Core Operating Limits Report

Braidwood Unit 2, Cycle 9A, Sequence Number 1

NUCLEAR FUEL MANAGEMENT DEPARTMENT
TRANSMITTAL OF DESIGN INFORMATION

Subject Braidwood Unit 2 Cycle 9A Core Operating Limits Report in ITS Format and W(z) Function

Figure 2.5.1:
Control Bank Insertion Limits Versus Percent Rated Thermal Power

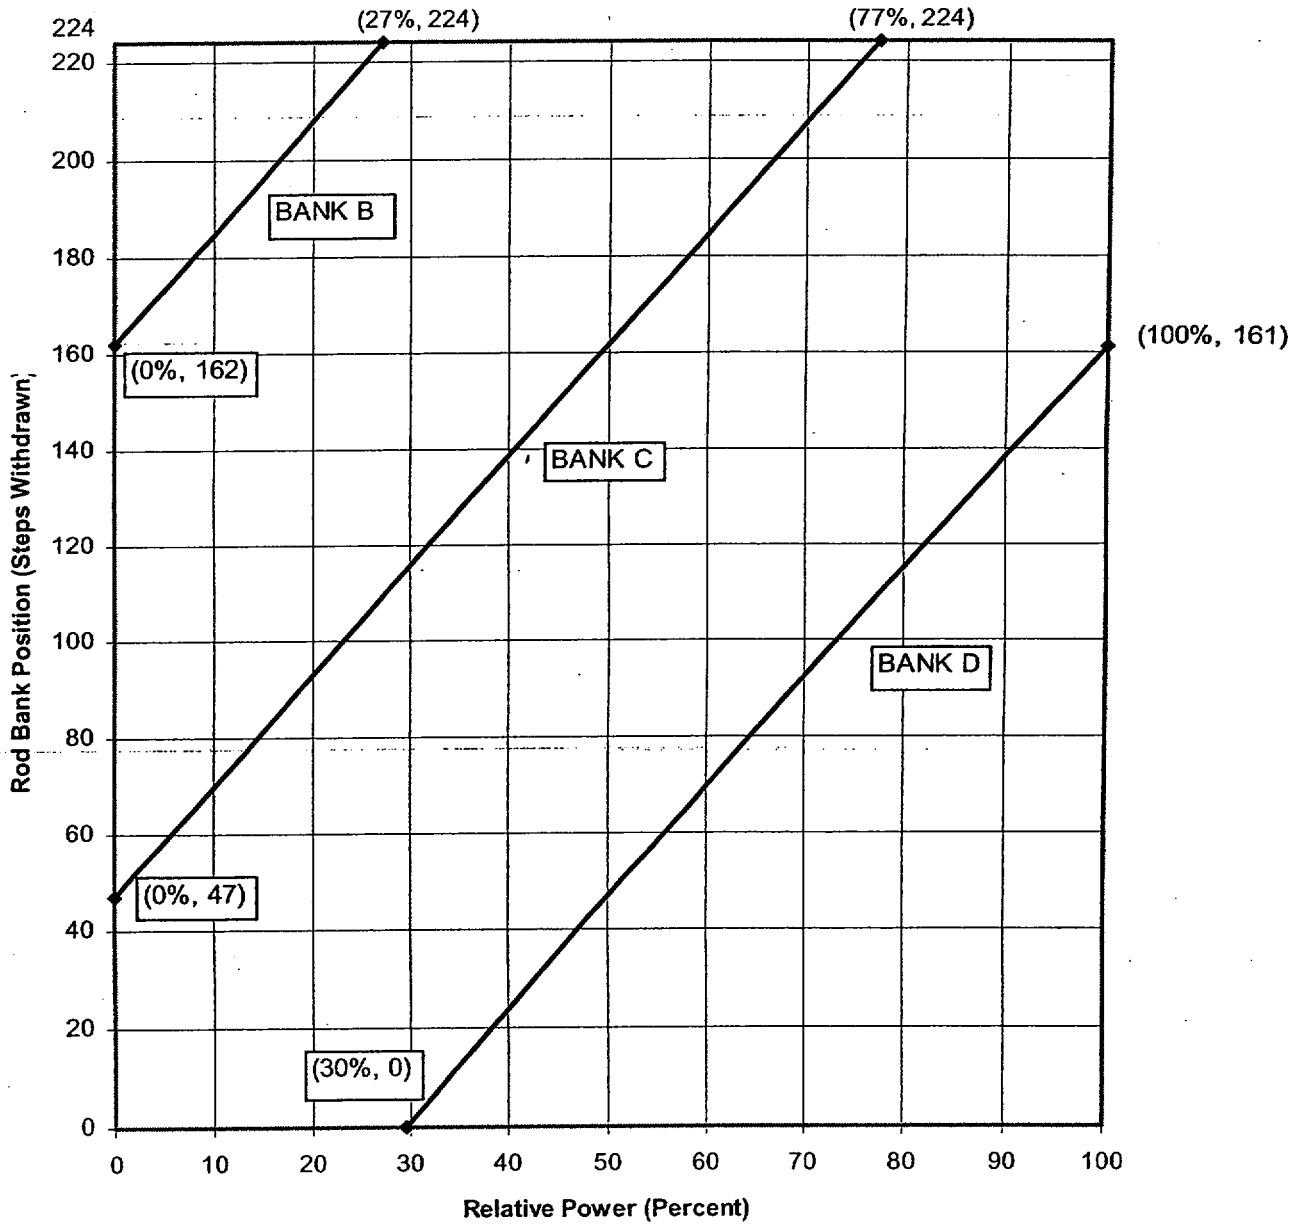
- Section 2.2.2; the SDM limits for MODE 5, applicable for LCO 3.1.1,
- Section 2.3.4, the EOL/ARO/HFP-MTC Surveillance limit at 60 ppm, applicable for LCO 3.1.3,
- Section 2.5.1, the control bank insertion limits, applicable for LCO 3.1.6.
- Section 2.5.4, the control bank overlap limits, applicable for LCO 3.1.6.
- Section 2.13.2, the Reactor Coolant System boron concentration, applicable to TLCO 3.1.k.2)

2.5.1 The control banks, with the Bank A greater than or equal to 224 steps, shall be limited in physical insertion as shown in Figure 2.5.1.
